Service Information

STUDER A67

Power supply 1.067.160

Mounting Rectifiers

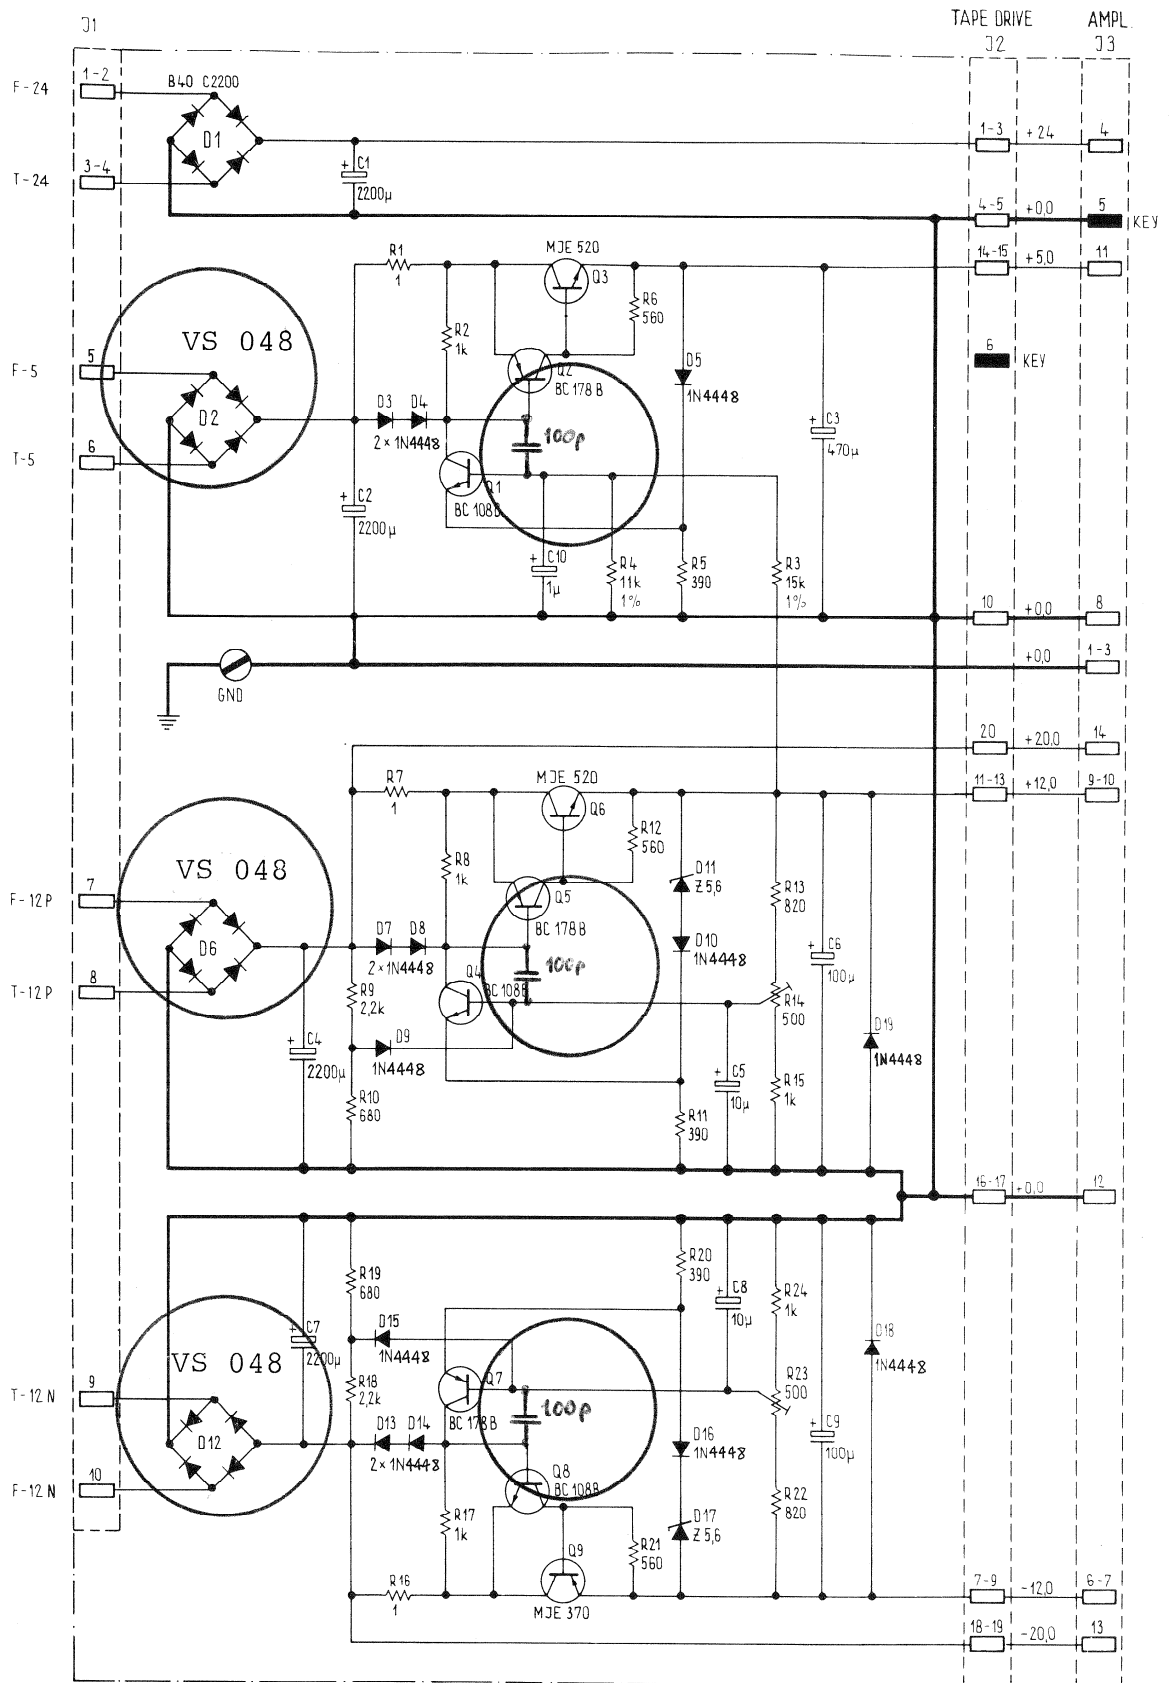
Further three capacitors 100 pF must be added to prevent oscillation. See enclosed drawing, board 1.067.160.

All three rectifiers D2, D6, D12 (board 1.067.160), the fuses F5 and F6 (mains transformer assembly) must be replaced.

- Unscrew rear panel and top panel plate
- Unscrew stabilizer board 1.067.160 (2 screws on top, one below)
- Remove power transistor RCA 411 that print can be removed.

- When assembling board 1.067.160 again make sure that the spooling motor wires fed between the power transistor cooling device and the stabilizer board do not get hurt.

Power supply
Netzteil
Alimentation
1.067.160

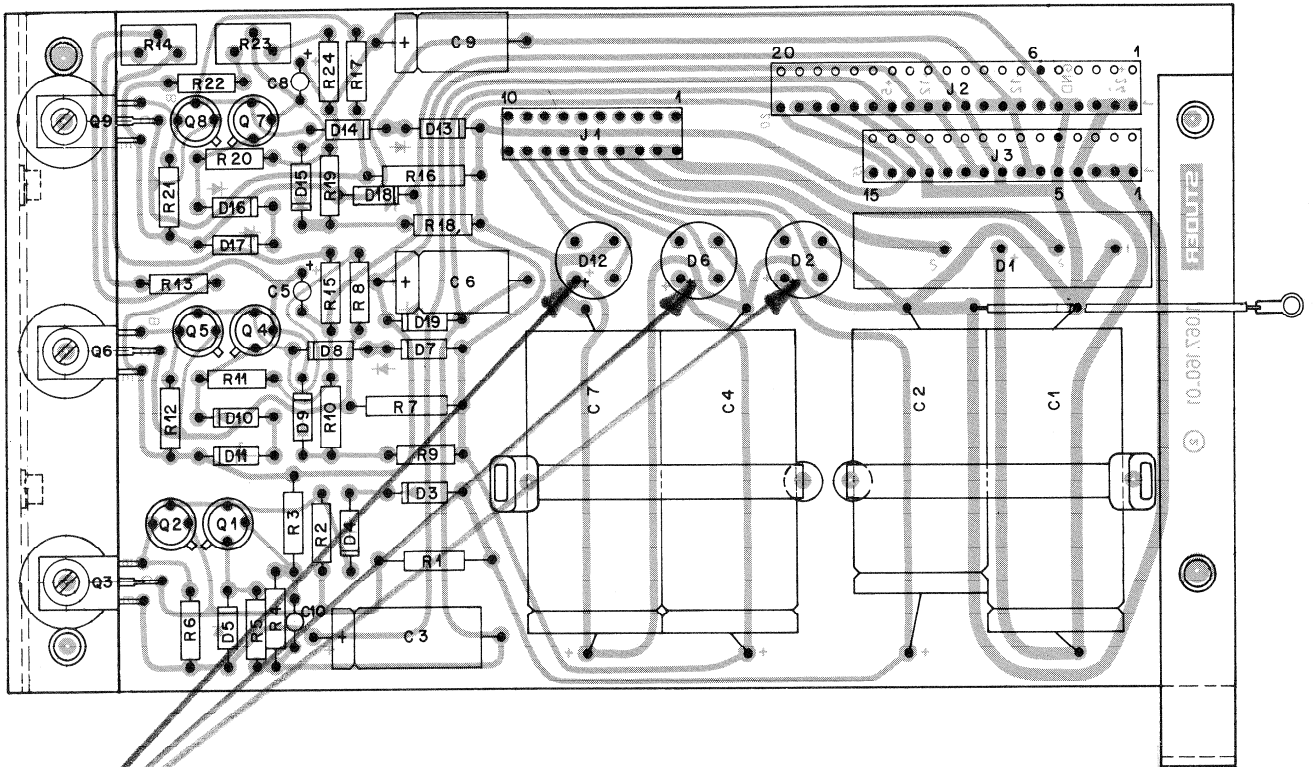
To be replaced by
VS 048

A 2 MAINS TRANSFORMER ASSEMBLY 1.067.140

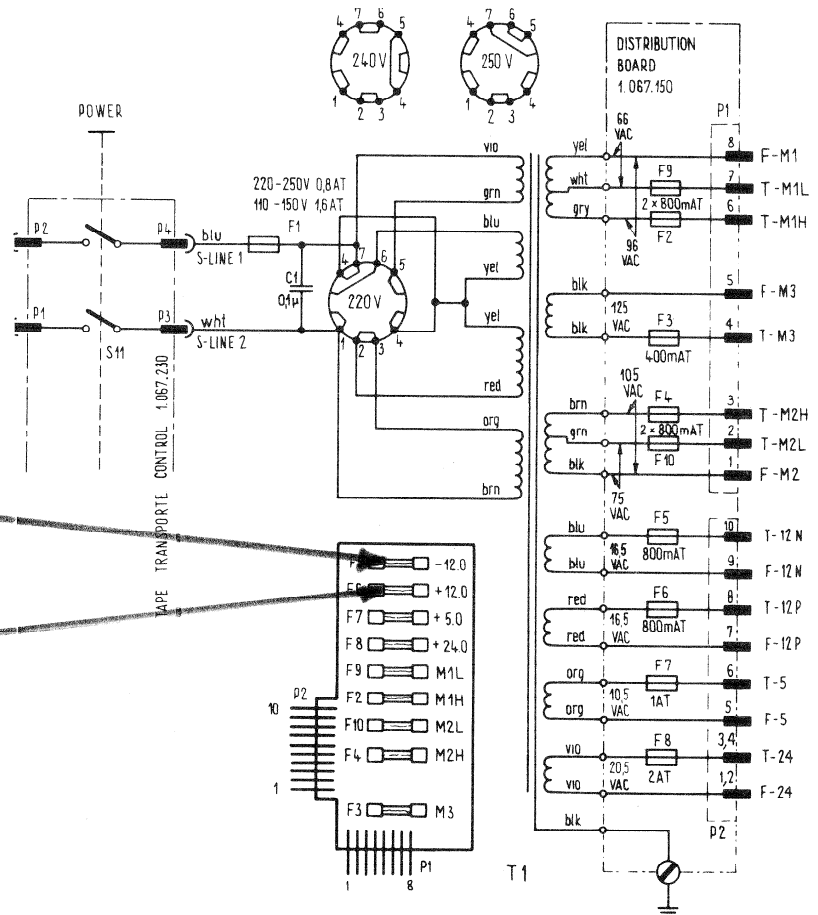
To be replaced by
1 AT

To be replaced by
1.25 AT
